COUNCIL ASSESSMENT REPORT

Panel Reference	2017SNH085
DA Number	327/15/8
LGA	North Sydney Council
Proposed Development	To modify Consent 327/15 for the construction of a 4-6 storey mixed use building, in respect of the number, mix and configuration of apartments, and construction of new awnings and façade changes
Street Address	101-111 Willoughby Road, CROWS NEST
Applicant/Owner	Ionic Management Pty Ltd / CN Plaza No.1 Pty Ltd
Date of DA lodgement	21 November 2017
Number of Submissions	Nil
Recommendation	Approval
Regional Development Criteria	Council-related development with Capital Investment Value (CIV) exceeding \$5 Million. Original consent was granted by the former Sydney East Joint Regional Planning Panel.
List of all relevant s4.15(1)(a) matters	<ul style="list-style-type: none"> • SEPP 65 Design Quality of Residential Apartment Development • SEPP (BASIX) 2004 • Sydney REP (Sydney Harbour Catchment) 2005 • North Sydney Local Environmental Plan 2013 • North Sydney Development Control Plan 2013

REPORT TO SYDNEY NORTH PLANNING PANEL

APPLICATION No: DA 327/15/8 / (2017SNH085)

Figure 1 – Proposed modifications

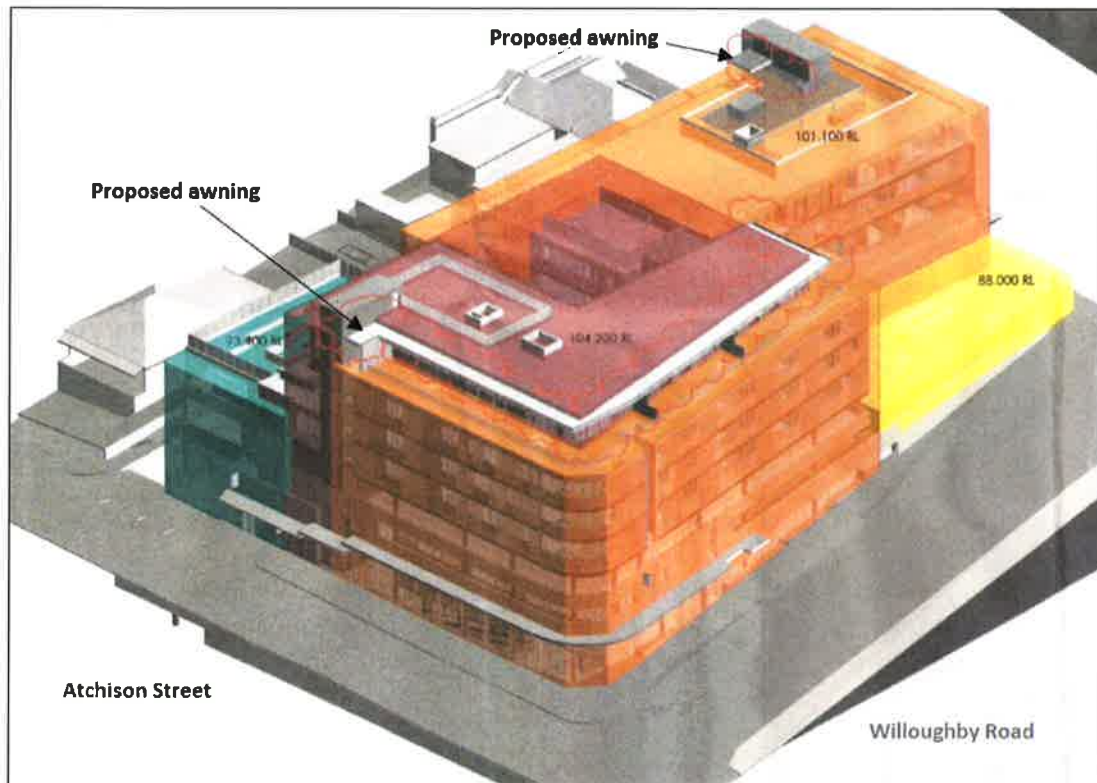
- Alter the number, mix and configuration of apartment units, by removing all studios, increasing 2- and 3-bedroom units, and thus reducing the approved seventy (70) apartments to sixty (60) apartments;
- Construction of new awnings over the Level 4 terrace on Building 1 and in front of the lift on Level 4 of Building 2; and
- Other minor external changes, including relocating the main switch room on ground level, and facade changes as a result of the apartment reconfiguration.

External modifications are illustrated in **Figure 1** and a floor-by-floor summary of modifications to the internal layout is provided in **Attachment 1**.

Figure 4 – Proposed modifications to the height of Building 01

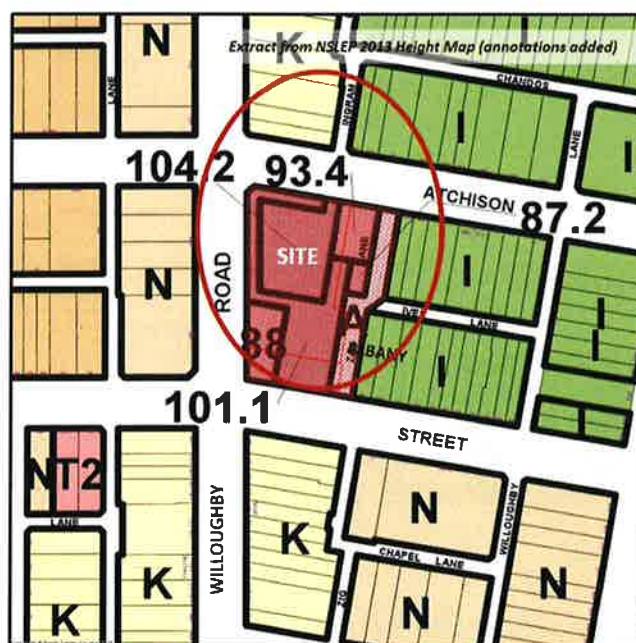
Clause 4.3 of LEP 2013 sets a variable maximum height for the subject site as shown below, with a maximum RL104.2 towards the north western corner of the site (in the location of approved Building 01), and maximum RL101.1 towards the south eastern corner of the site (in the location of approved Building 02) (Figure 4).

**Figure 5 – Building 01 awning complies with maximum building height
Building 02 exceeds height control**

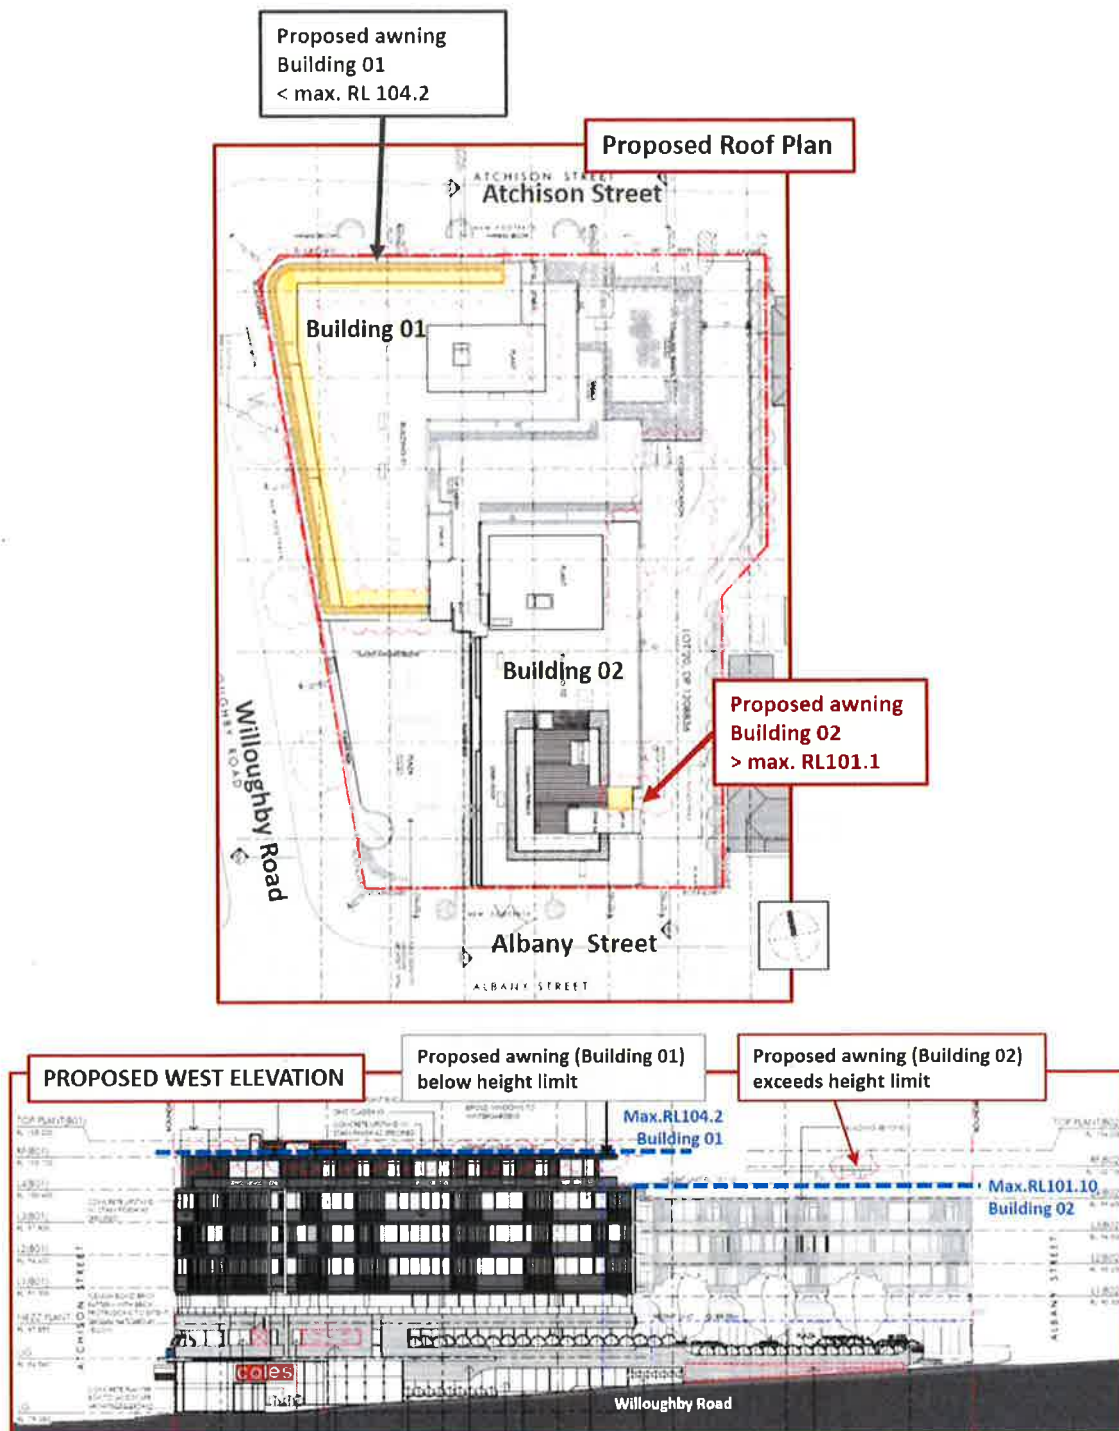
The proposed modifications comply with the maximum height of buildings controls, with the exception of the proposed awning in front of the approved lift on Level 4 of Building 02 (**Figure 5**).

The development as proposed to be modified will give rise to an additional height breach in the location of the new awning on the roof level of Building 02, as detailed in the table below.

LEP Max RL	Approved Height	Proposed	
			Height	Complies
Building 01	RL104.2	RL103.72 (roof) RL101.6 (balustrade)	RL103.72 (new awning) RL 101.6 (planter)	Yes
Building 02	RL101.1	RL104.2 (top of plant) RL102.2 (roof terrace pergola) -	(no change) (no change) RL102.6 (new awning)	No

The additional breach of the height control is minor and associated with an awning that does not give rise to any significant increase in the approved building envelope which remains substantively compliant with the height control. The proposed awnings give weather protection to approved roof level facilities and there is no public benefit in maintaining the control on the site in this instance. Compliance of the modifications with the height control is unnecessary and unreasonable as the development satisfies the objectives of the control despite the variation.
